DA-B DRAWINGS AMENDED AS SHOWN CLOUDED 29/01/2018 Y T AHM DA-A ISSUED FOR DEVELOPMENT APPLICATION 03/08/2017 Y T **AMENDMENT**

MIXED USE DEVELOPMENT 4-14 Mark St Lidcombe, NSW 2141

**REVISION B:** - Fire stairs relocated to north eastern corner

Section B

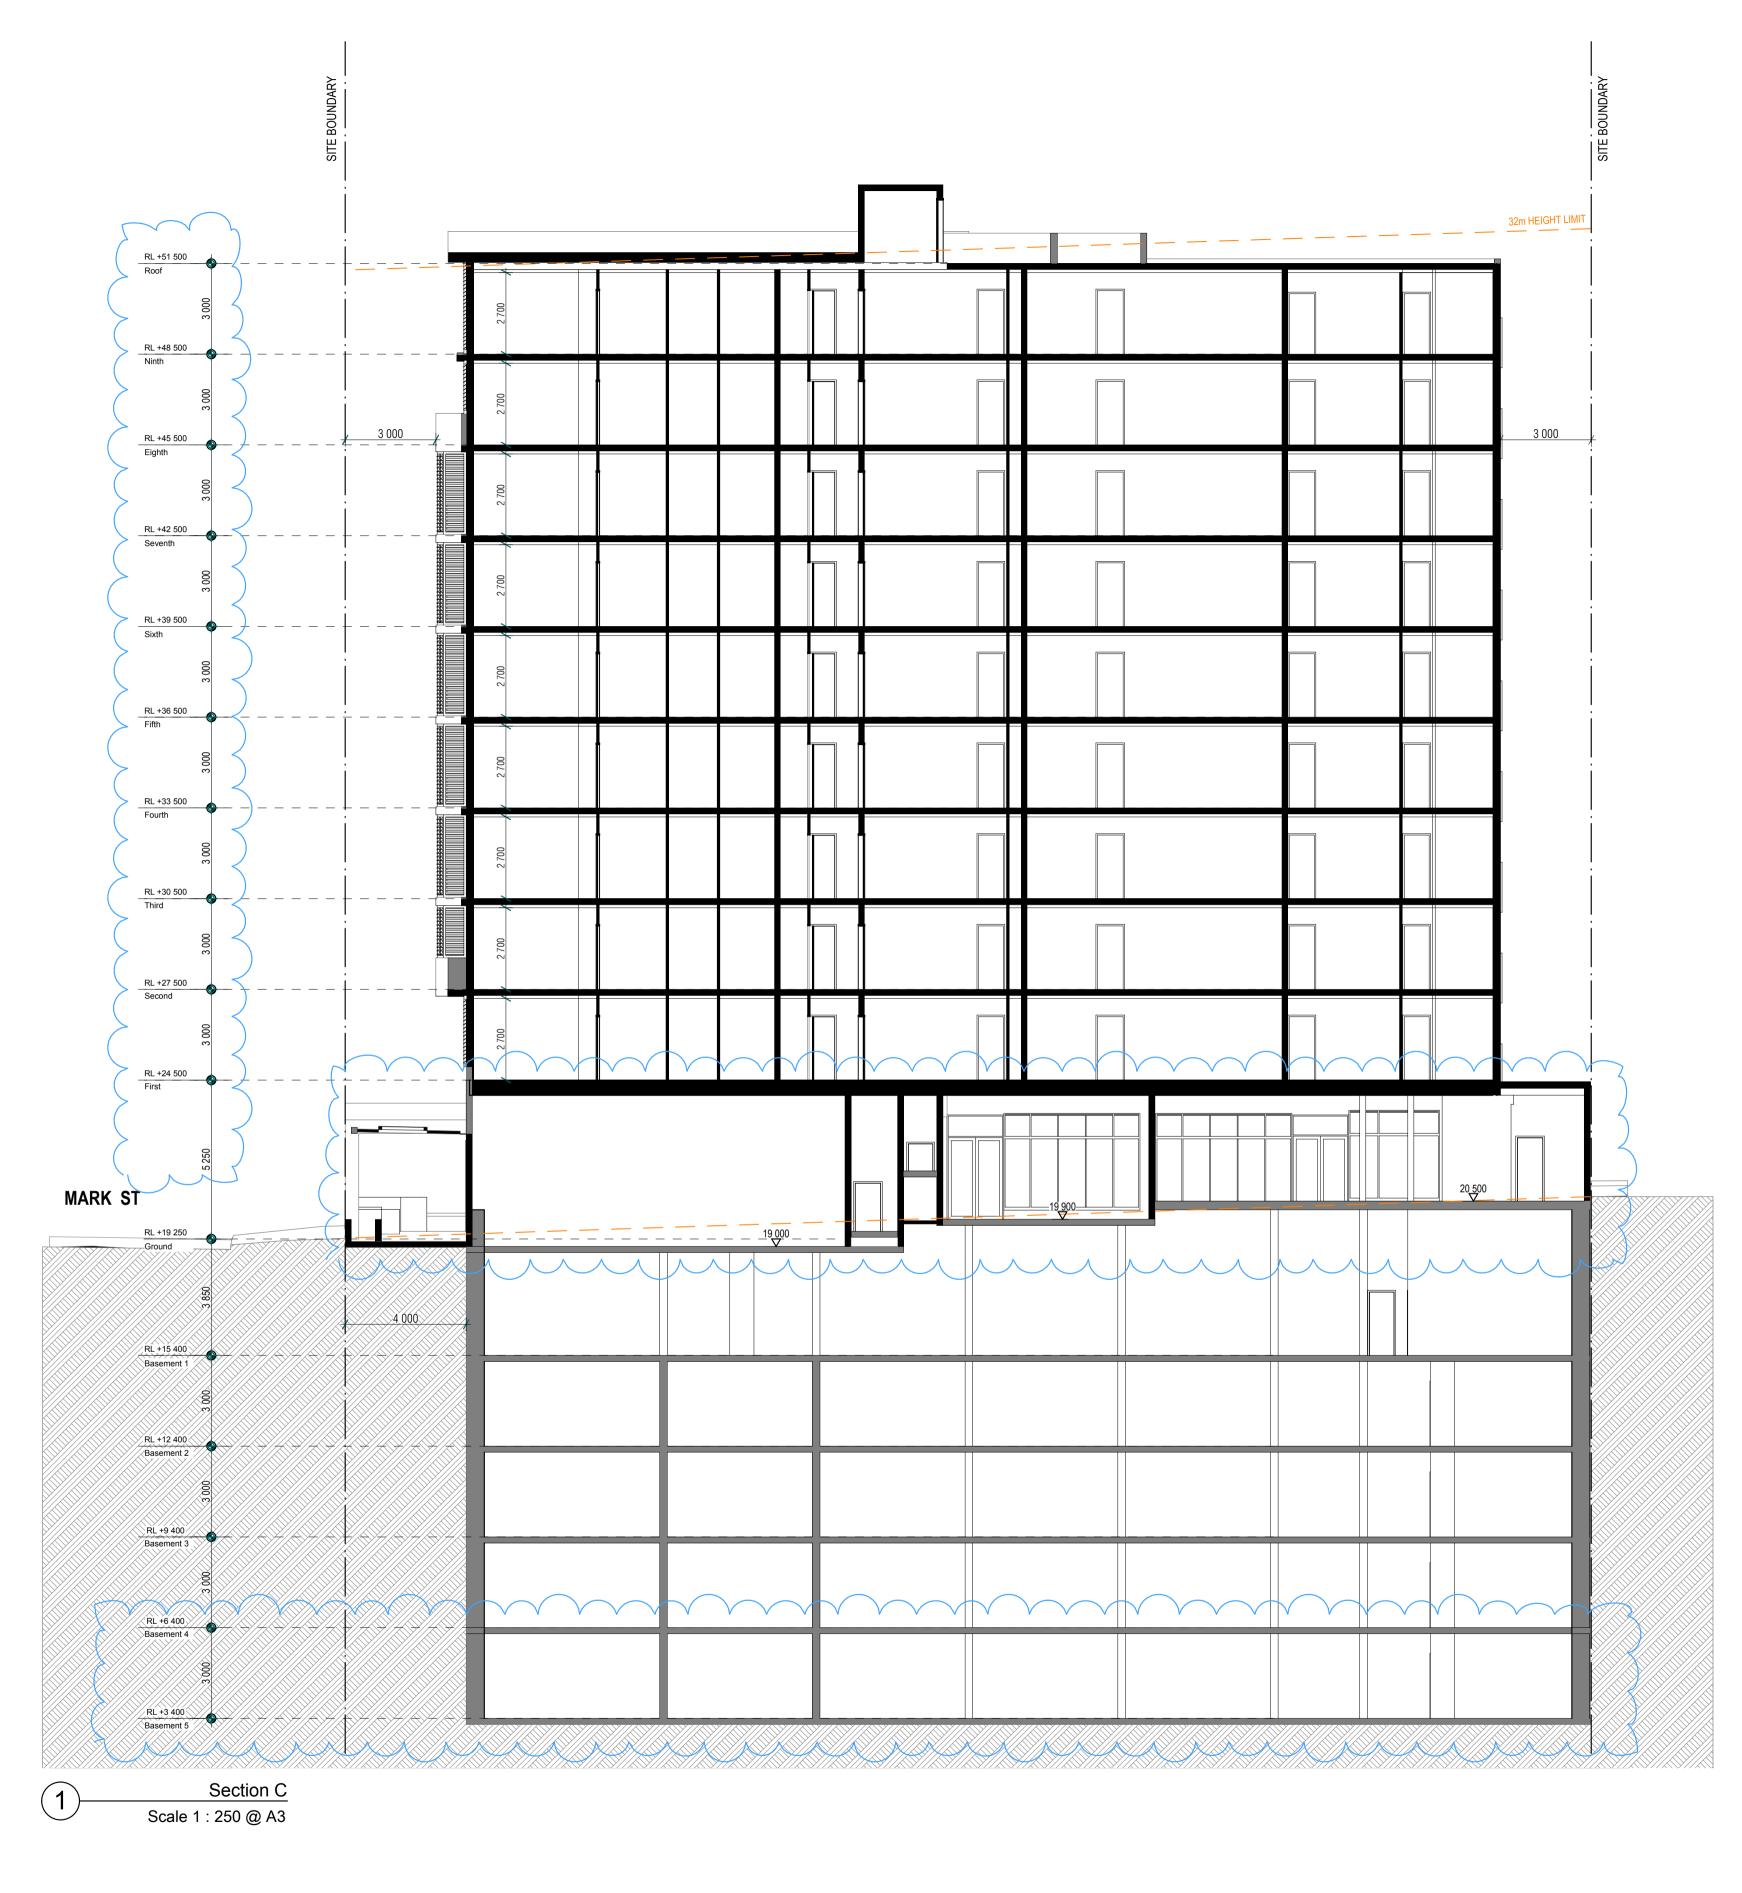
All residential units (previously proposed) on Ground converted to commercial areas
Ground to Level 1 floor height increased by 500mm, upper floors follow
Add rooftop terrace COS to tower B, connected by accessible ramps to tower A rooftop terrace
Add one basement level ( B5 ) **REVISION B:**

#### SHEET TITLE: East Elevation DESIGNED: DRAWN: COMMENCED: SCALE: PRINT: 1:125@A1 A3 SHEET 1:250@A3

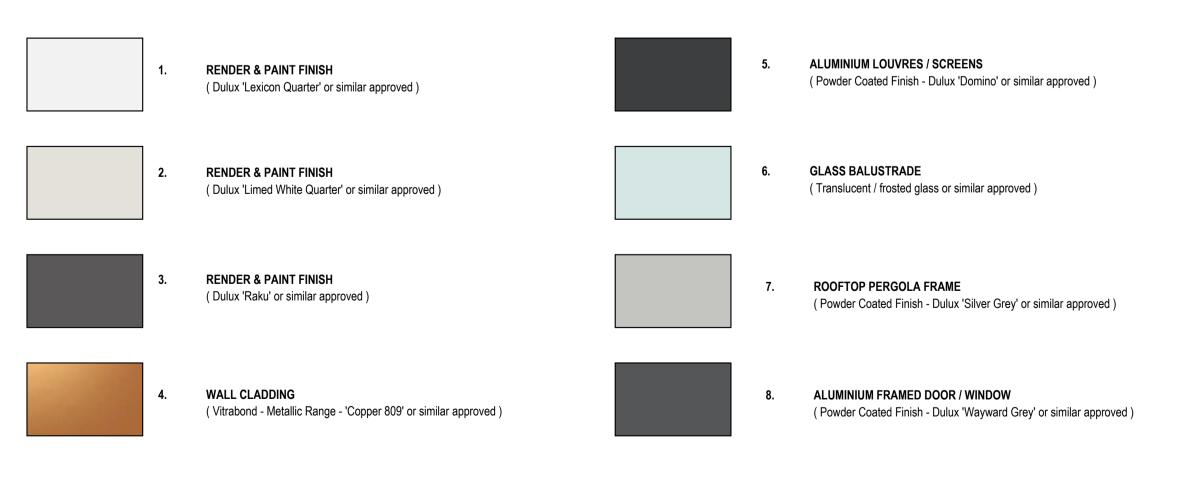
#### Ground to Level 1 floor height increased by 500mm, upper floors follow Add rooftop terrace COS to tower B, connected by accessible ramps to tower A rooftop terrace **REVISION B:**

# SHEET TITLE: South Elevation DESIGNED: DRAWN: COMMENCED: SCALE: PRINT: AHM YT March 2017 1:125@A1 A3 SHEET 1:250@A3

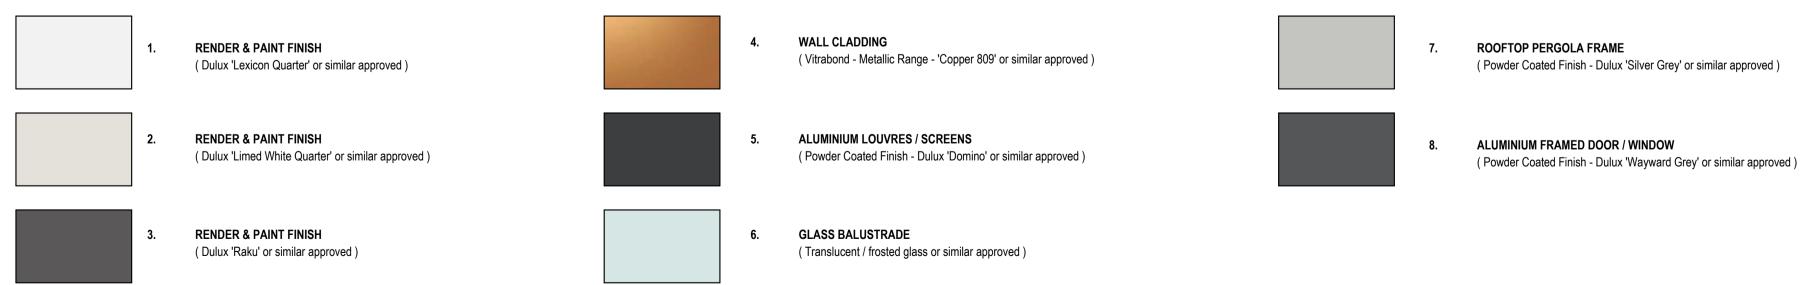
### REVISION B : - Ground to Level 1 floor height increased by 500mm, upper floors follow - Add rooftop terrace COS to tower B, connected by accessible ramps to tower A rooftop terrace
